## Addendum No. 5

Project Name: NECSD – New CTE Building

CSArch Project No. 108-2303

This Addendum No. 5 forms part of the Contract Documents and modifies the original bidding documents dated April 15, 2024. Addendum No. 5 consists of 3 pages, 9 specification sections, and 31 drawings.

7 DOMESTIC WATER SERVICE ENTRANCE DETAIL  
P301 NOT TO SCALE

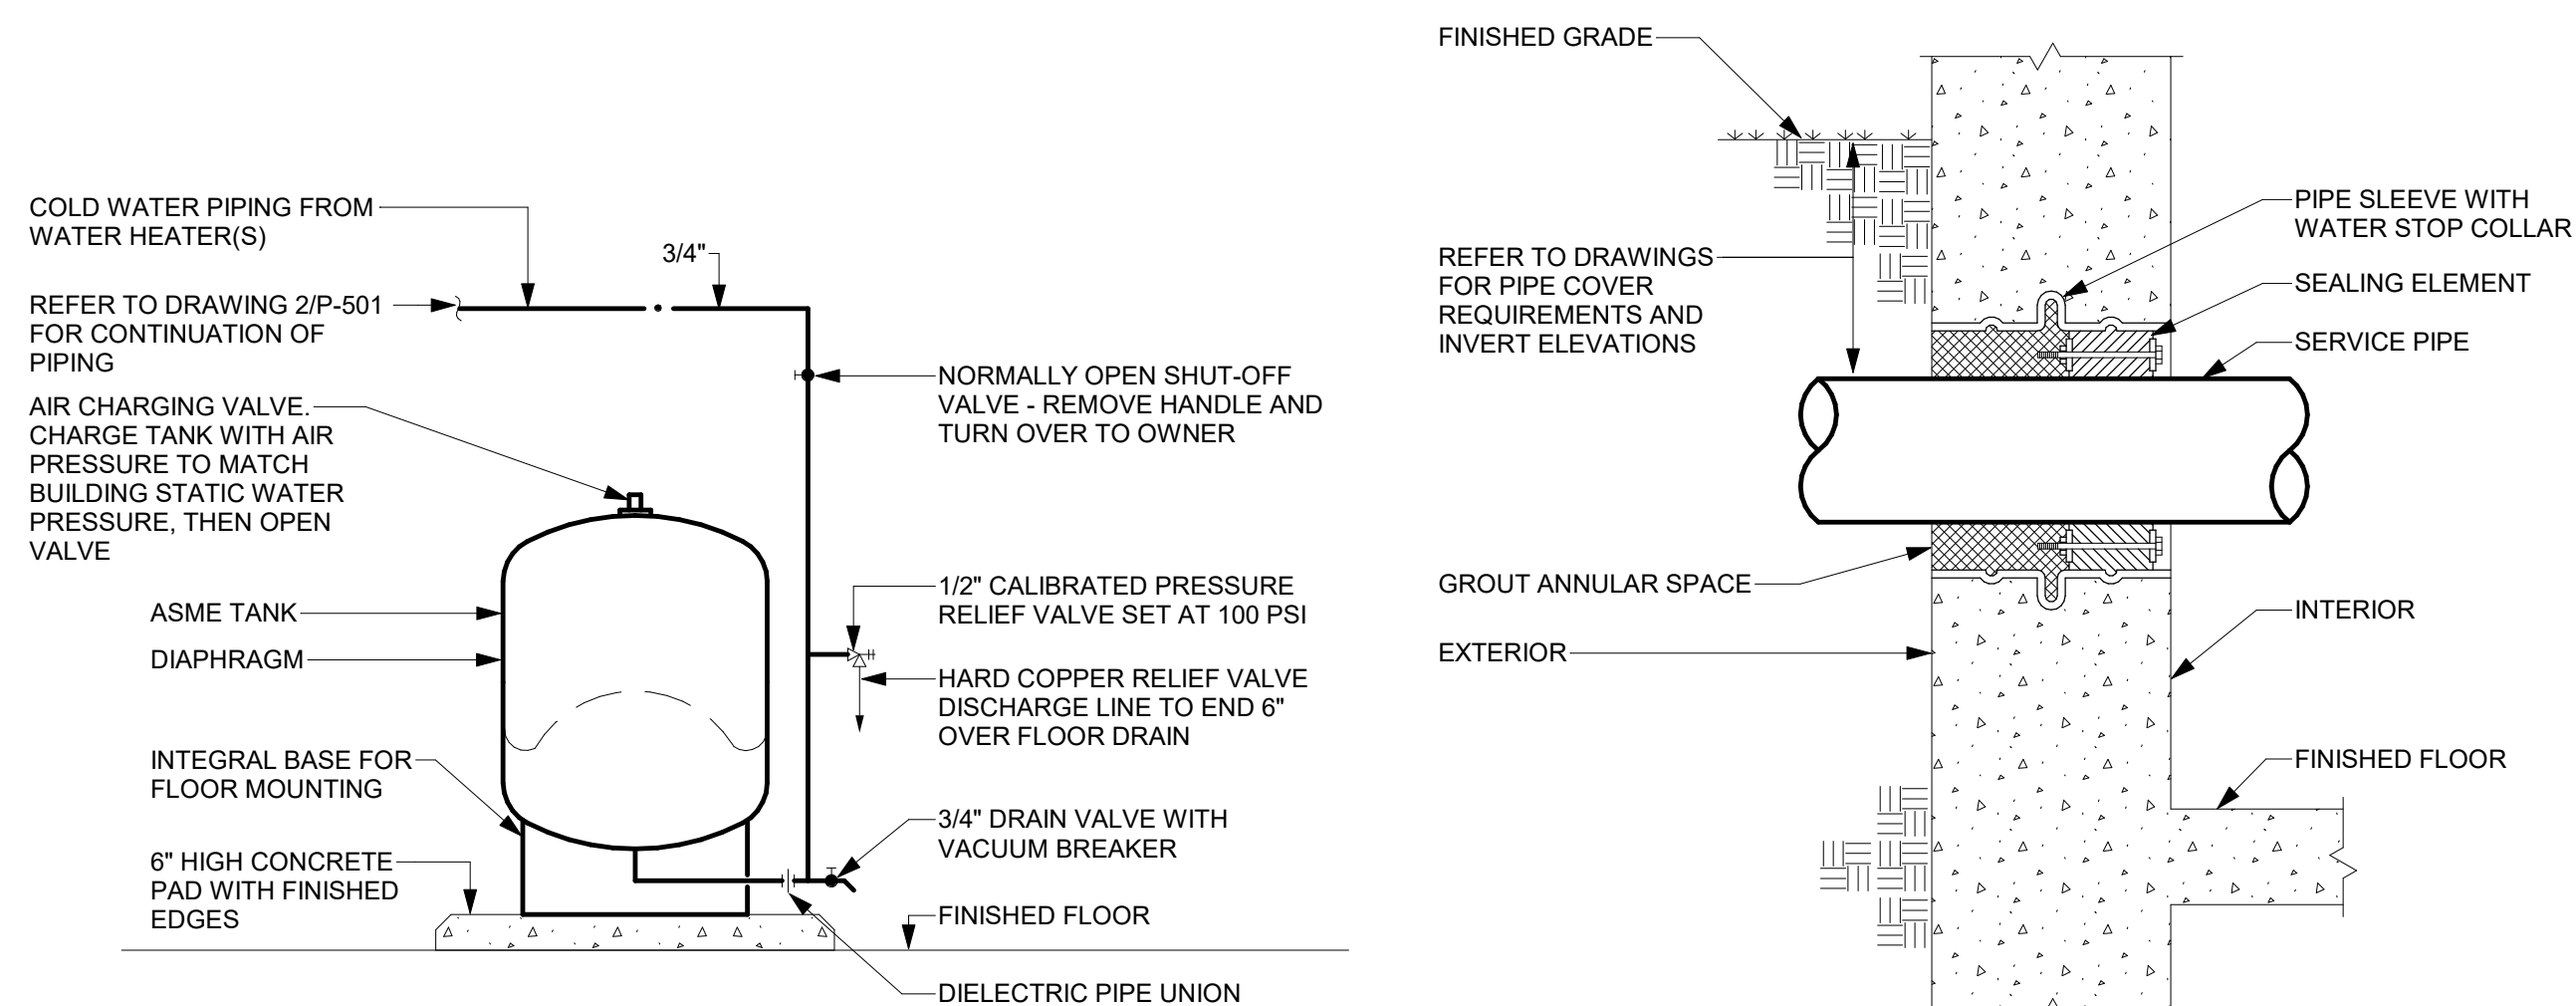
- 78 6" COMBINED DOMESTIC AND FIRE WATER SERVICE
- 79 4" DOMESTIC WATER METER AND STRAINER
- 80 TWO DOMESTIC WATER REDUCED PRESSURE BACKFLOW PREVENTERS IN PARALLEL. SEE DETAIL 7 P301 FOR DETAILS

2 GREASE INTERCEPTOR DETAIL  
P301 NOT TO SCALE

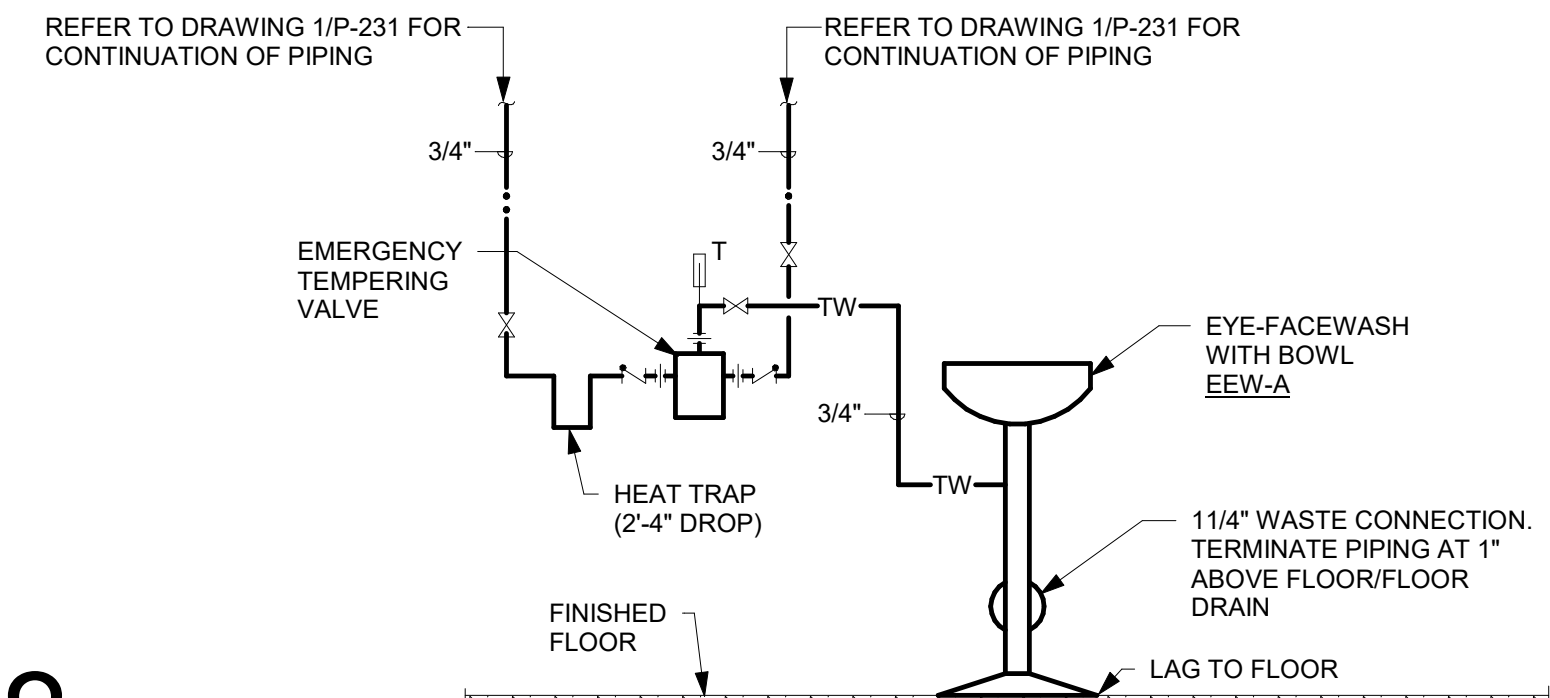
15	P	Oil Separator / Grease Interceptor	As per drawing P-301 please provide sizes for oil separator and grease interceptor.	4/30/2024	Worth Construction Co., Inc.	Provided as part of addendum #2	Yes	P301		Add #2
16	P	Lavatories	As per schedule on drawing P-001, LV-a, b & c schedule is 1, 3 & 4 stations. Written spec show 1, 2 & 3 stations. Please advise.	4/30/2024	Worth Construction Co., Inc.	Provided as Part of addendum #2	Yes	P001	224000	Add #2
17	G	3d Model	Is there a 3D model of this building available?	5/1/2024	Rizzo Companies	There is a 3d model, but it is <b>NOT</b> part of the bidding documents. The model can be shared with the contractor once the contract is awarded.	No			
18	G	Instructions to Bidders	Section 00 21 13 "Instructions to Bidders" page 9 - 4.3/D reads "Bids shall be submitted in duplicate". Section 00 11 16 "Advertisements for Bids" page 1 reads "One copy of sealed bids...." and "One copy of bid in PDF format...". Please clarify if the sealed bid shall include two (2) hard copies of the bid submission, in addition to a PDF copy of the bid emailed the next day.	5/1/2024	EW Howell Construction Group	What is outlined in the Advertisement for Bids is correct. Revision to the Instruction to Bidders has been provided as part of addendum #2.	Yes		002113	Add #2
